REMARKS

Marked-up Copy of Amended Claims

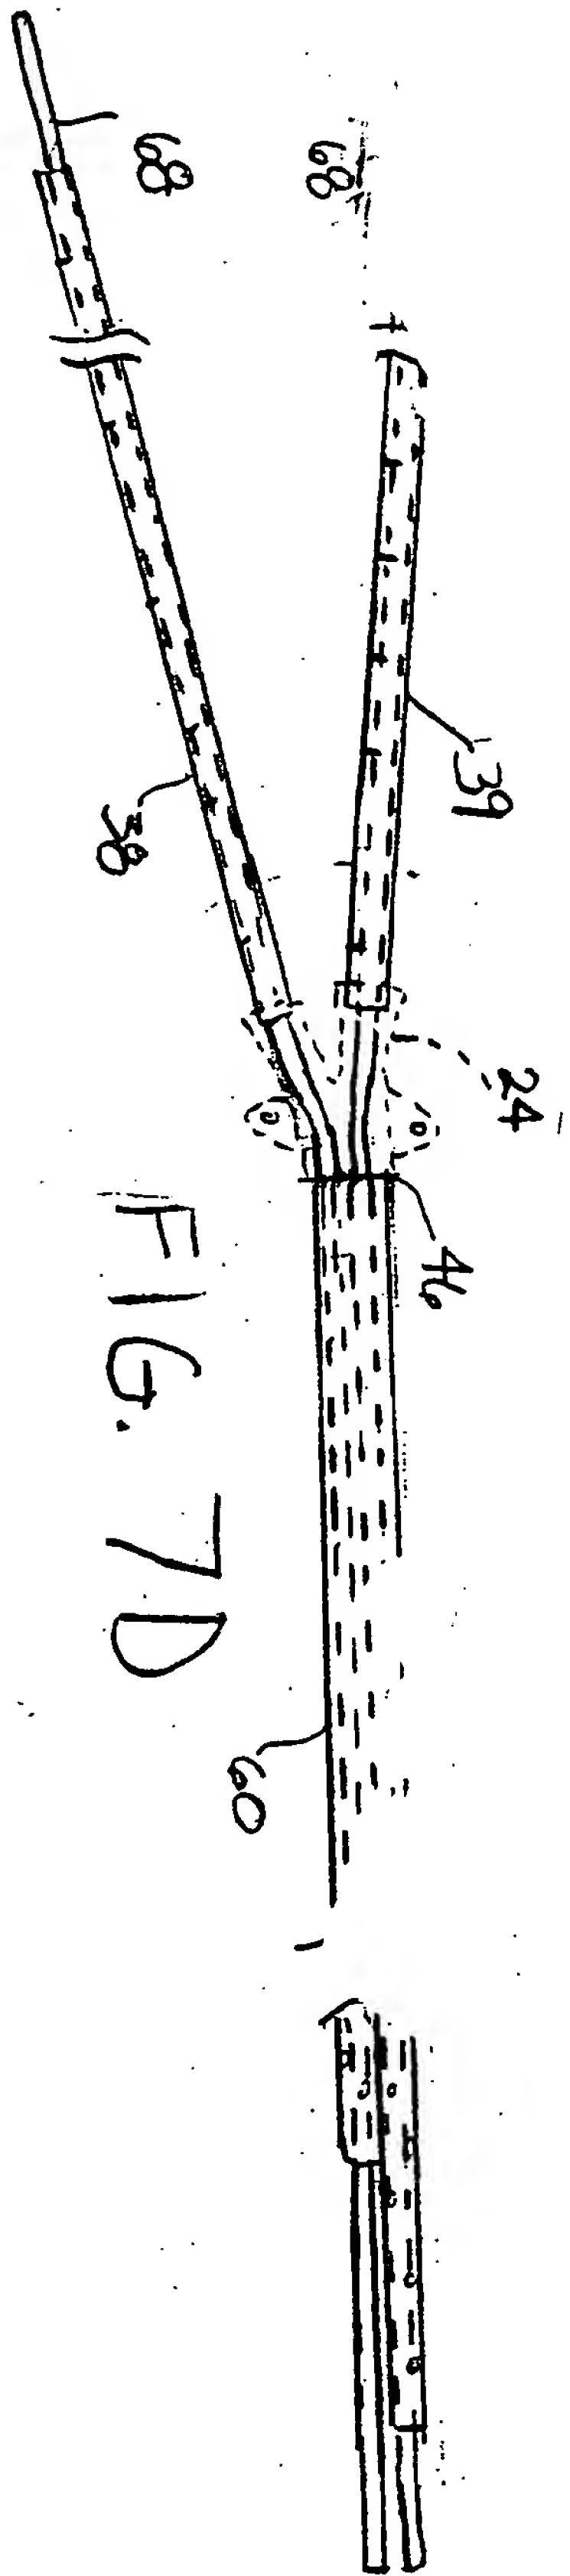
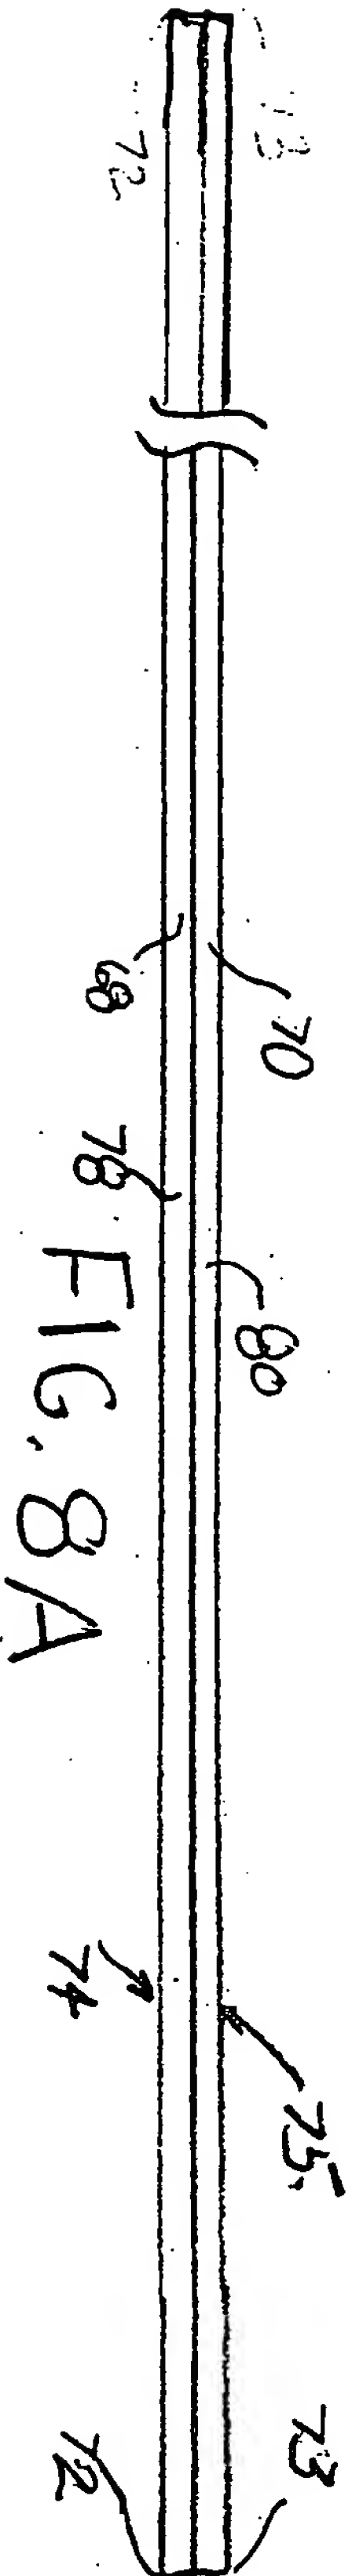
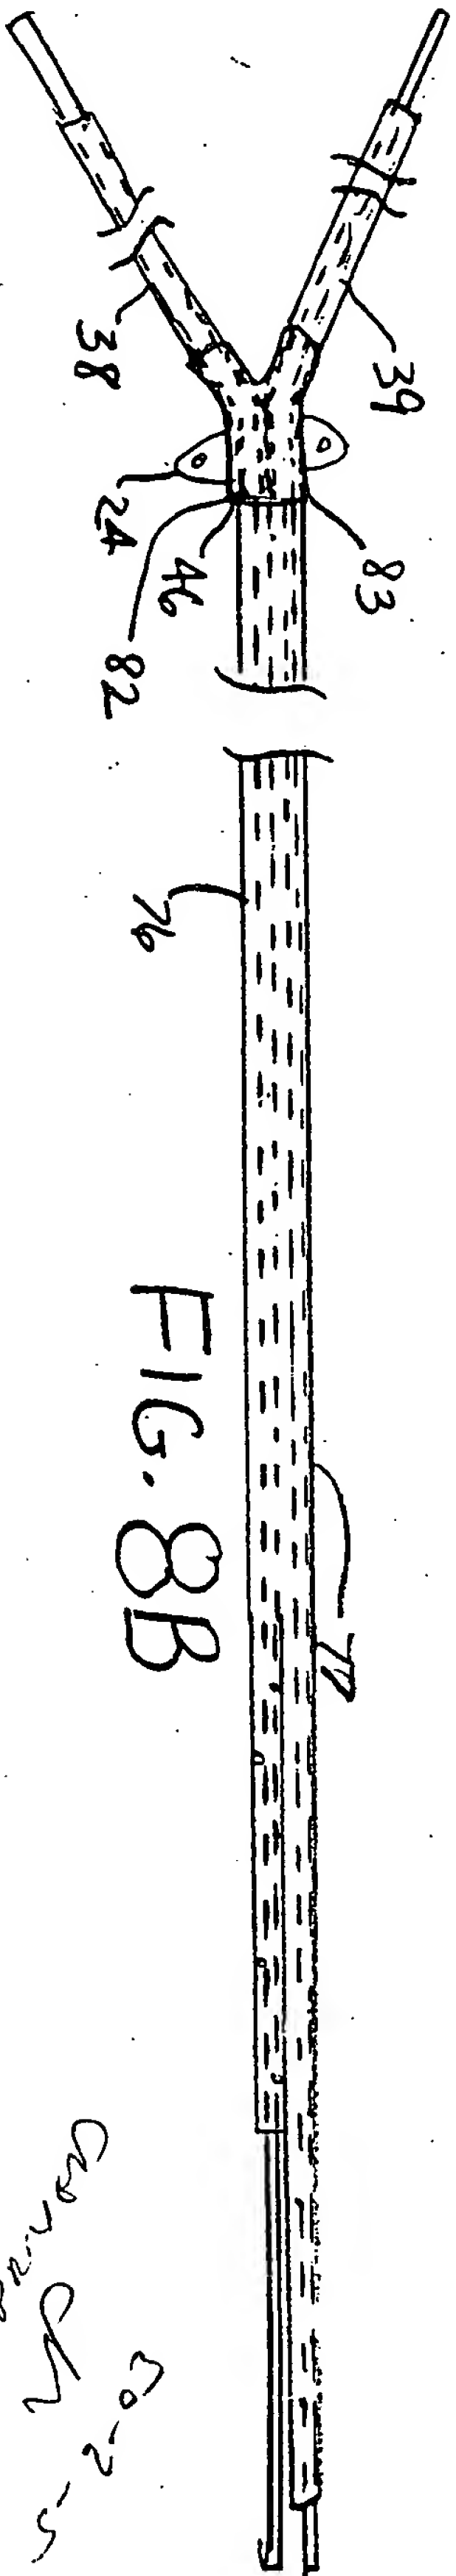
With the present amendment, claims 24, 25, 28-30, and 36-42 are pending. In the Office Action, the Examiner objected to the drawings because Figs. 7A through 8B were shown too close together. Applicants propose modifying the drawings by moving Figs. 7D-8B to a new page and spacing out Figs. 7A-7C, as enclosed. Applicants respectfully submit that the drawings are now not too close together, and respectfully request the objection to the drawings be withdrawn.
